ATTACHMENT 2
PROPOSED CATAWBA TECHNICAL SPECIFICATION
REVISED FIGURES 3.4-2, -3

FIGURE 3.4-2 CATAWBA NUCLEAR STATION, REACTOR COOLANT SYSTEM, HEATUP LIMITATIONS APPLICABLE FOR THE FIRST 10 EFY

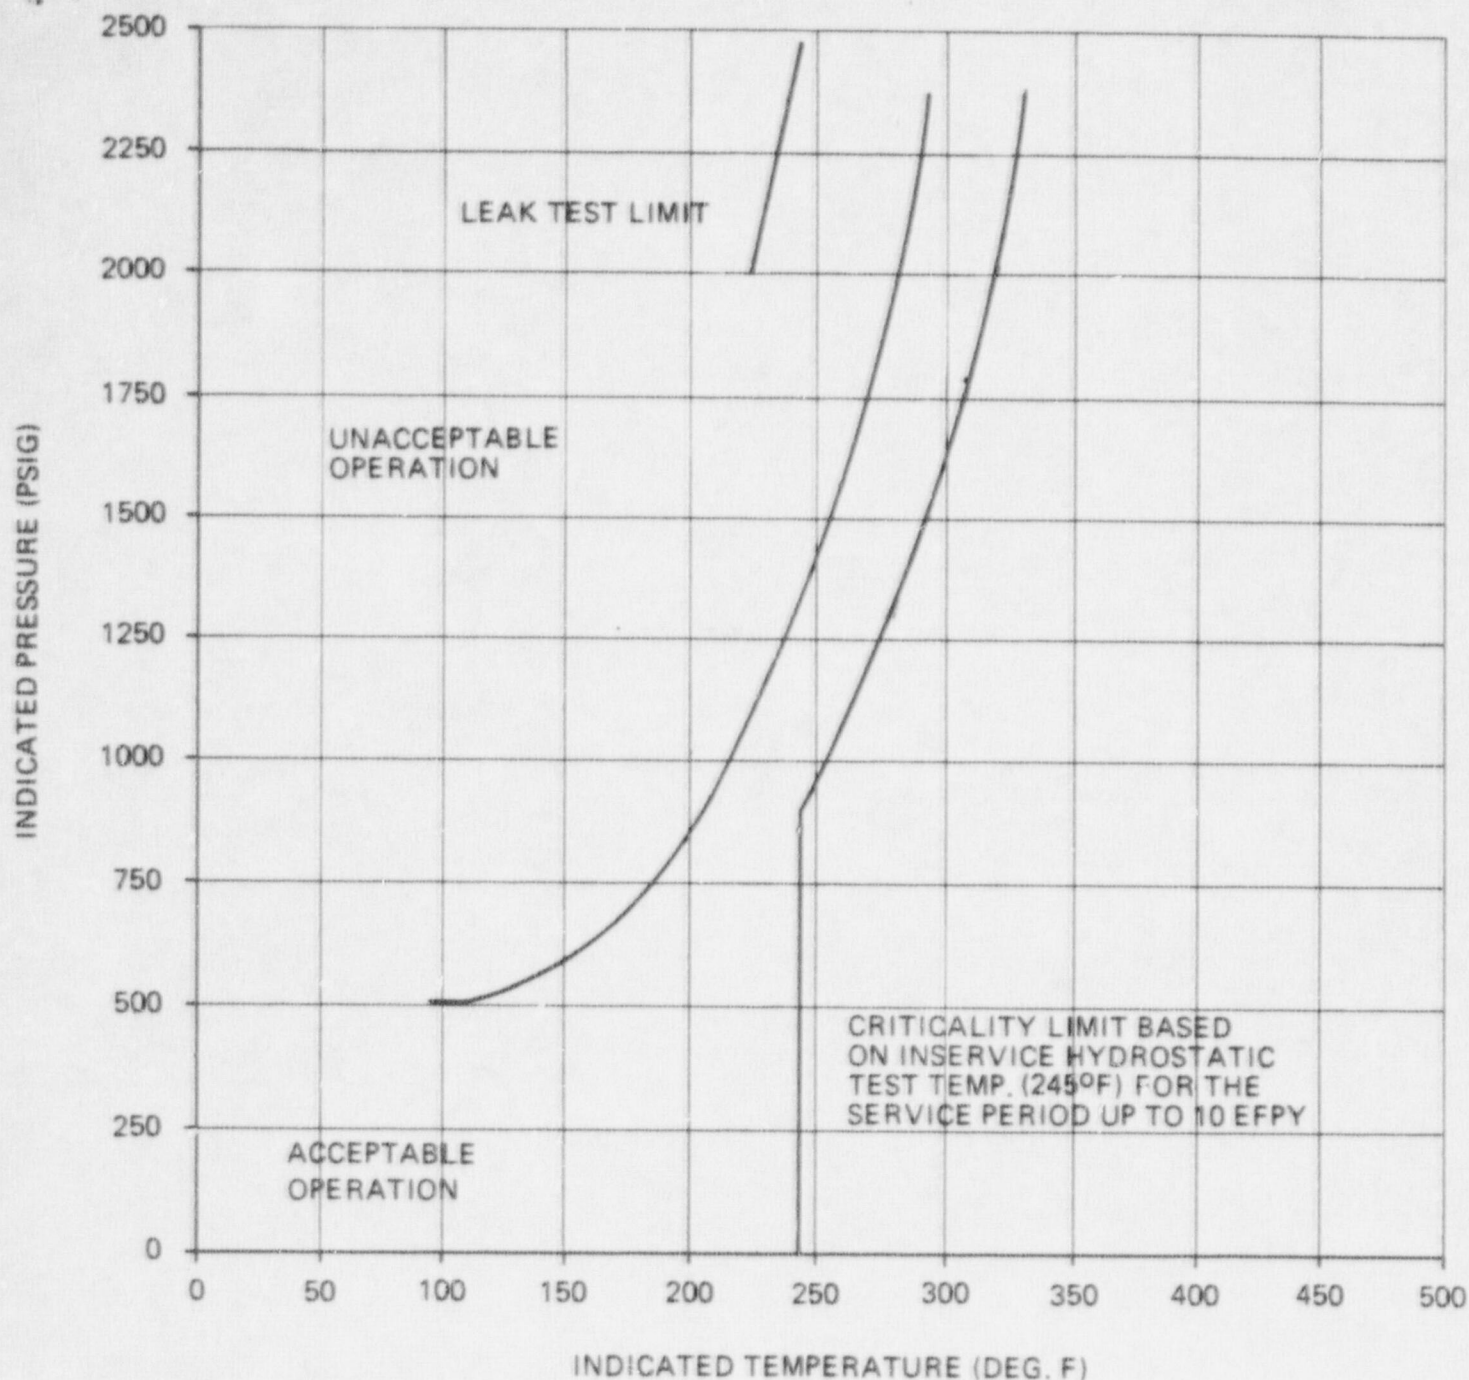
CURVE APPLICABLE FOR HEATUP RATES UP TO 60°F/HR FOR THE SERVICE PERIOD UP TO 10 EFY. CONTAINS MARGIN OF 10°F AND 60 PSIG FOR POSSIBLE INSTRUMENT ERRORS.

MATERIAL BASIS
CONTROLLING MATERIAL—UNIT 2 INTERMEDIATE SHELL
PLATE B8605-2
COPPER CONTENT—0.07wt%
NICKEL CONTENT—0.61 wt %
RT_{NDT} INITIAL—33°F
RT_{NDT} AFTER 10 EFY 1/4T, 104°F
3/4T, 92°F

FIGURE 3.4-3 CATAWBA NUCLEAR STATION, REACTOR COOLANT SYSTEM, COOLDOWN LIMITATIONS APPLICABLE FOR THE FIRST 10 EFPY

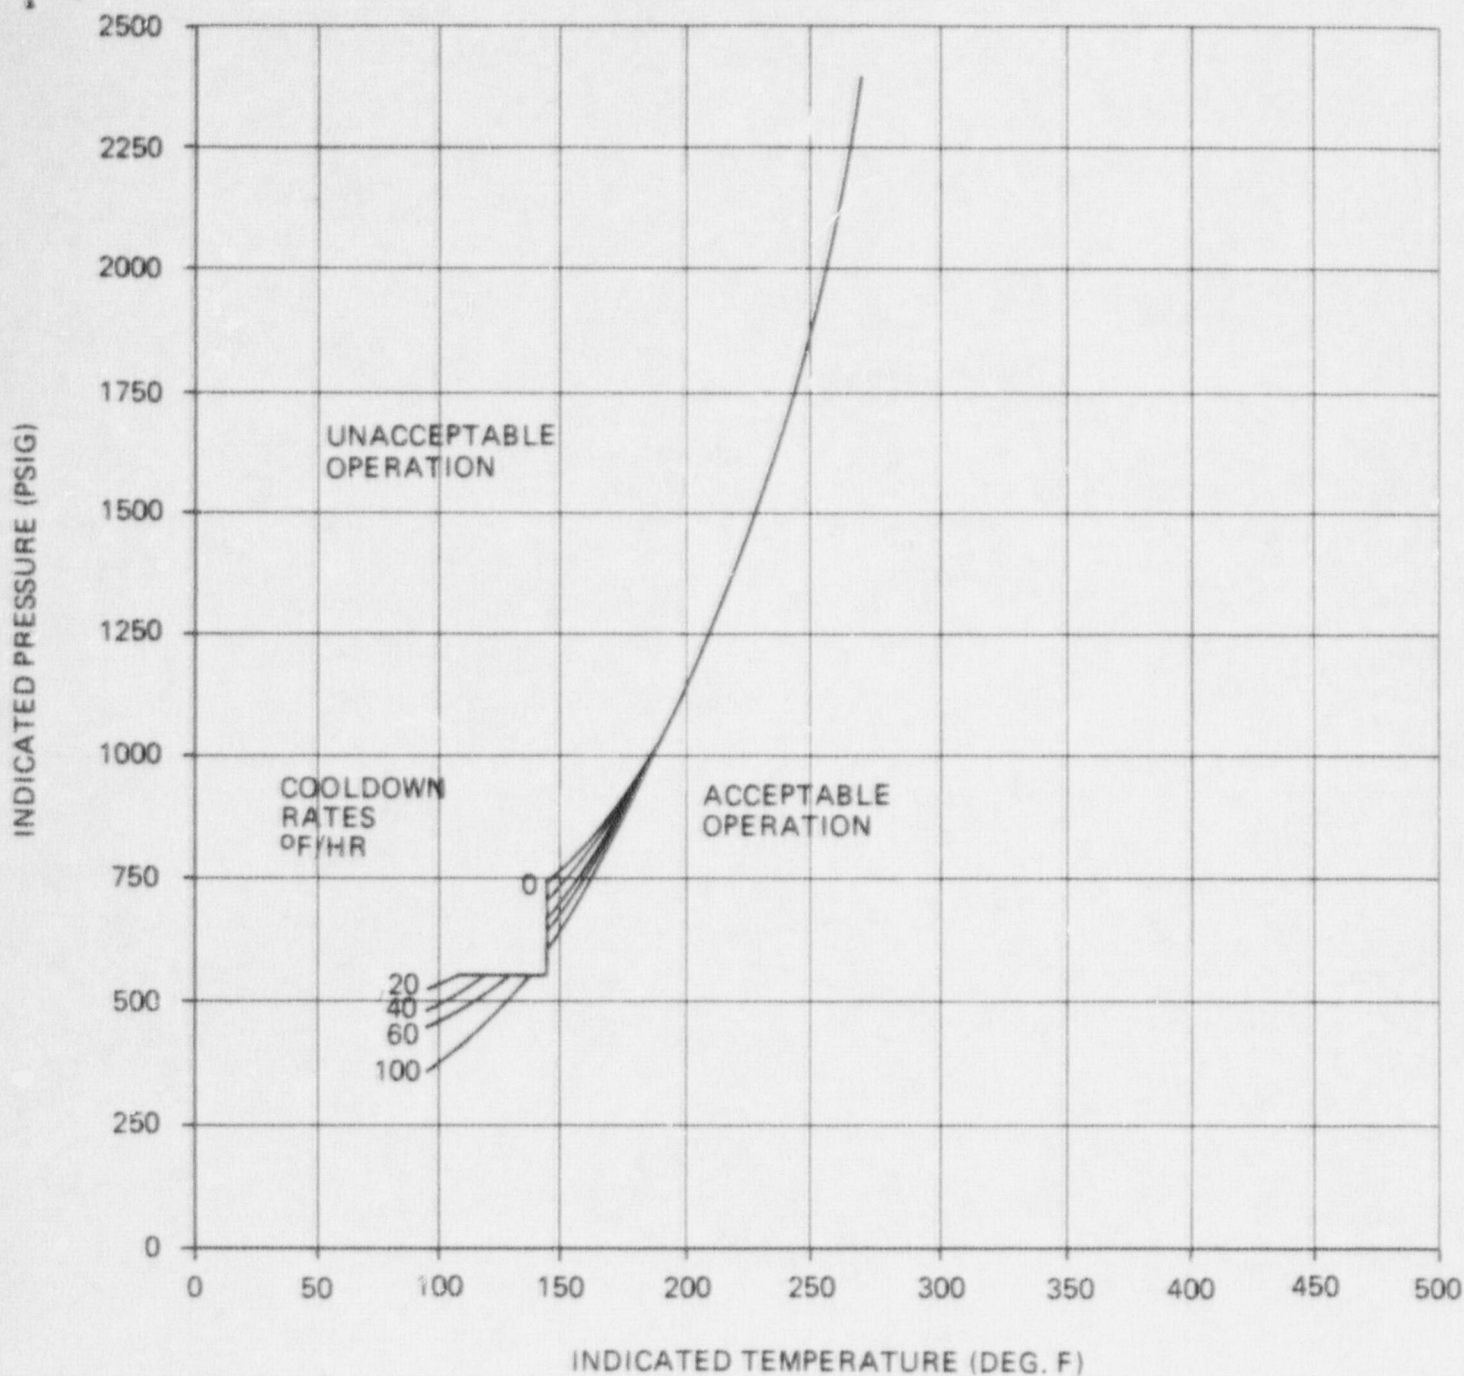
CURVE APPLICABLE FOR COOLDOWN RATES UP TO 100°F/HR FOR THE SERVICE PERIOD UP TO 10 EFPY CONTAINS MARGIN OF 10°F AND 80 PSIG FOR POSSIBLE INSTRUMENT ERRORS.

MATERIAL BASIS
CONTROLLING MATERIAL—UNIT 2 INTERMEDIATE SHELL
PLATE B8605-2
COPPER CONTENT—0.07 wt%
NICKEL CONTENT—0.61 wt%
RT_{NDT} INITIAL—33°F
RT_{NDT} AFTER 10 EFPY 1/4T, 104°F
3/4T, 82°F
